**MICROCHIP****PIC18F2525/2620/4525/4620****PIC18F2525/2620/4525/4620 Rev. A4 Silicon Errata**

The PIC18F2525/2620/4525/4620 Rev. A4 parts you have received conform functionally to the Device Data Sheet (DS39626), except for the anomalies described below. Any Data Sheet Clarification issues related to the PIC18F2525/2620/4525/4620 will be reported in a separate Data Sheet errata. Please check the Microchip web site for any existing issues.

**The following silicon errata apply only to PIC18F2525/2620/4525/4620 devices with these Device/Revision IDs:**

**FIGURE 1: SCK PULSE VARIATION USING TIMER2/2**

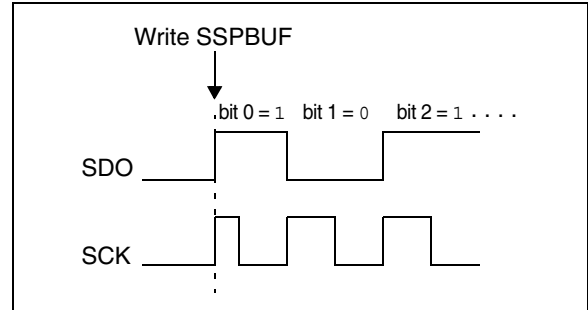
When the SPI is using Timer2/2 as the clock source, a shorter than expected SCK pulse may occur on the first bit of the transmitted/received data (Figure 1).

To avoid producing the short pulse, turn off Timer2 and clear the TMR2 register, load the SSPBUF with the data to transmit and then turn Timer2 back on. Refer to Example 5 for sample code.
